Council Reference: DA09/0466.03 LN71624
Your Reference: MP08_0234 MOD 4

MP08_0234 MOD 4 (Council reference DA09/0466.03) - Modification to approved Concept Plan comprising residential, retirement living, retail, commercial, school and open space precincts at Lot 31 DP 850230; Conmurra Avenue BILAMBIL; Lot 1 DP 1033807 & Lot 1 DP 1033810 & Lot 1 DP 595529 & Lot 2 DP 867486 & Lot 32 DP 1085109 & Lot 33 DP 1085109 & Lot 4 DP 822786; Marana Street BILAMBIL HEIGHTS; Lot 2 DP 555026; No. 147 McAllisters Road BILAMBIL HEIGHTS

Figure 1: Extract of product Summary from original Visual Impact Assessment prepared by LVO Architecture dated 24/03/2009

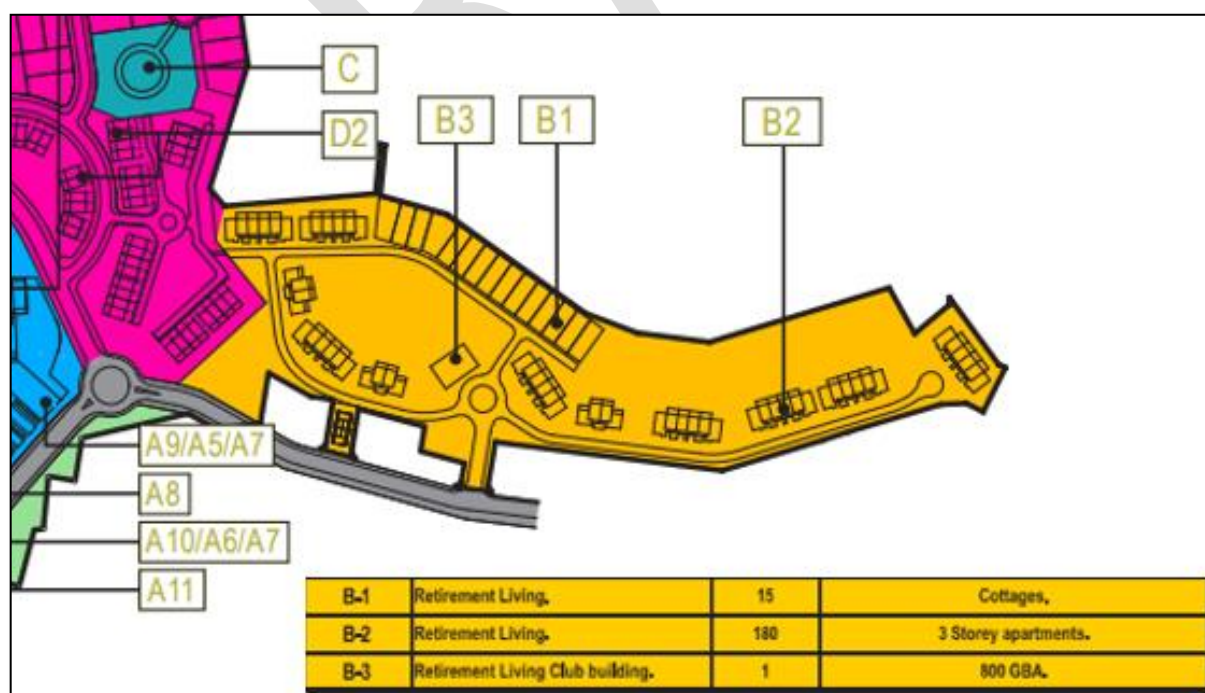
The approved Concept Plan enabled the provision of "Retirement Living" within Precinct B of "The Rise" Estate. The approved project permits a total maximum dwelling yield of 195 dwellings within this precinct. The maximum permitted building height is 2 storeys to the north of the precinct and 3 storeys to the south (see Figure 1 below).

Figure 2: Extract of approved Concept Plan sourced from applicants Modification Report

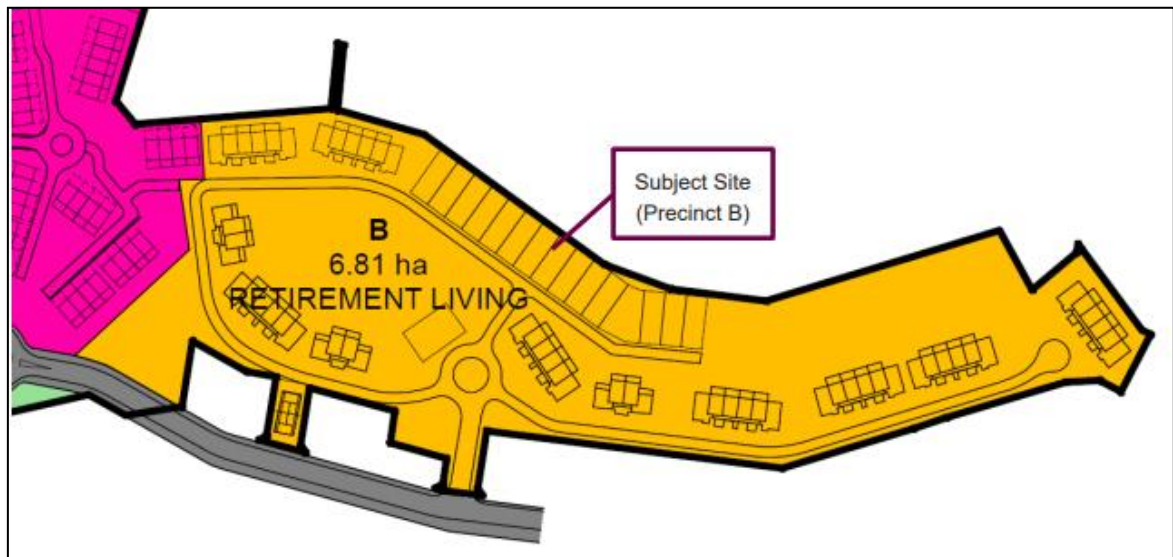
Based on a review the approved documentation, the distribution of built form in the Concept Plan detail enabled adequate building separation which is conducive to the topographical nature of the site and would protect the amenity impacts of existing built form in the surrounding development, which comprises of R2 Low Density zone with a maximum permitted building height of 9m (see Figure 2 & 3 below).

Figure 3: Extract of TSC GIS Mapping demonstrating max. permitted height of 9m to surrounding development

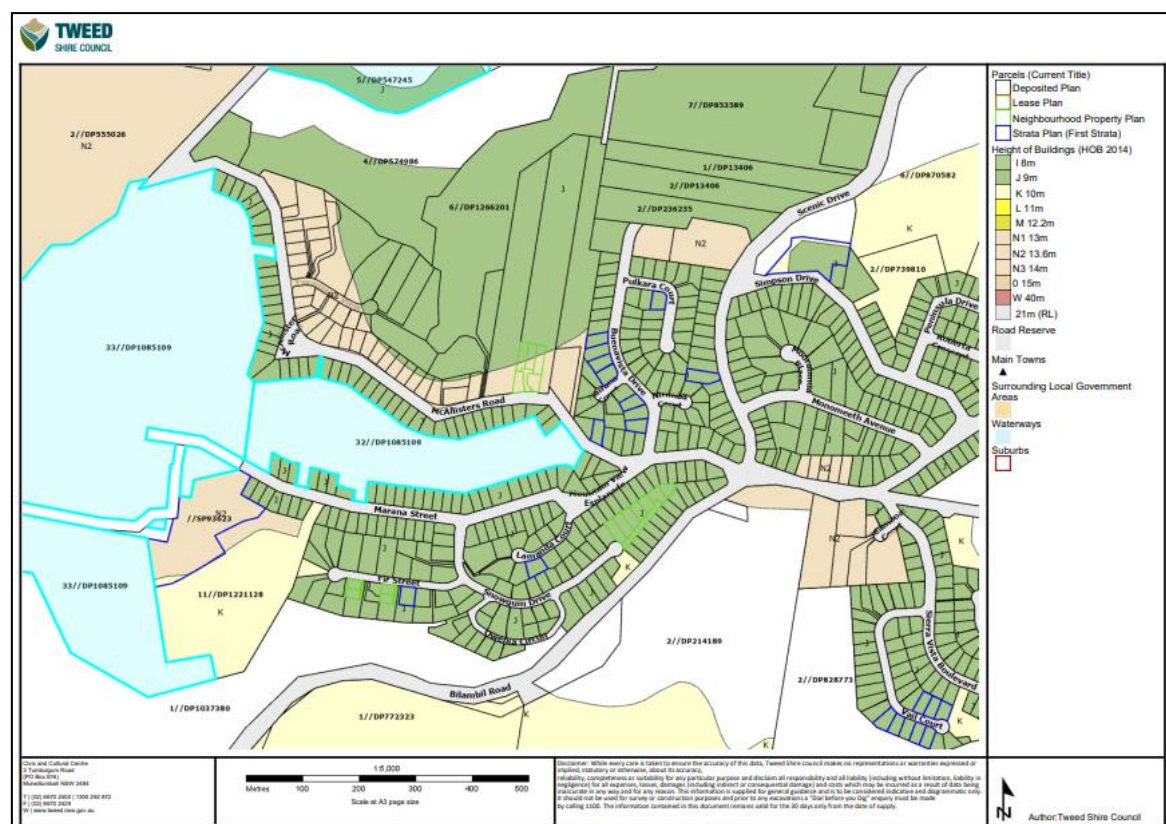
Concerns are raised over the integration of built form between the existing low density development to the perimeter of the subject site and the proposed maximum permitted building heights. In the absence of concept plans to demonstrate that an appropriate overall outcome can be achieved in terms of cross viewing, building separation, overshadowing and the like, the consent authority cannot be satisfied that development outcomes are conducive to the existing context and setting of the site and surrounds.

Figure 4: Extract of submitted Site Access Plan prepared by the applicant - red circle highlighting proposed additional option for access

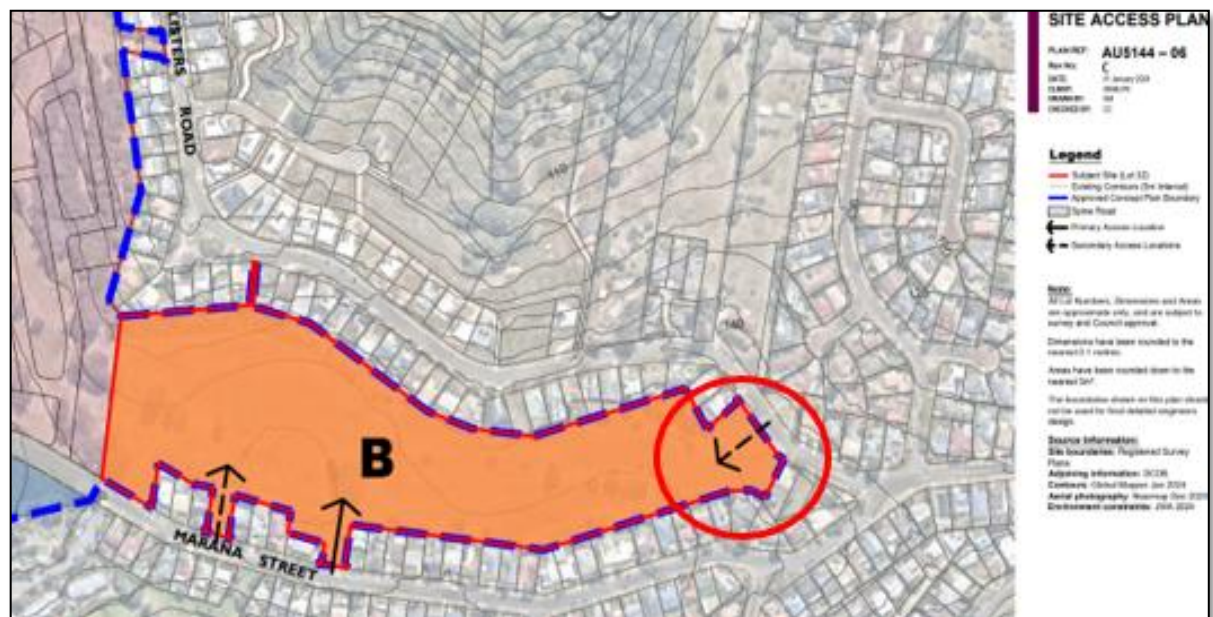
understood that the proposal seeks to remove the internal road layout and provide an optional access point to McAllister's Road per Figure 4 below.

There are concerns that the proposed access directly to McAllisters Road (in the location nominated in Figure 4 plan detail) may not comply with sight distance requirements according to Austroads Guide to Road Design Part 4a. Any such proposal is to be assessed and modelled in consideration of the expected traffic movements. There are also concerns that appropriate road gradients cannot be provided at the proposed intersection given the topographical constraints of the site and surrounding road network (see Figure 5 below). It is expected that any modification to the Major Project approval demonstrate compliance of the aforementioned provisions can be achieved prior to the issuing of a modified consent.
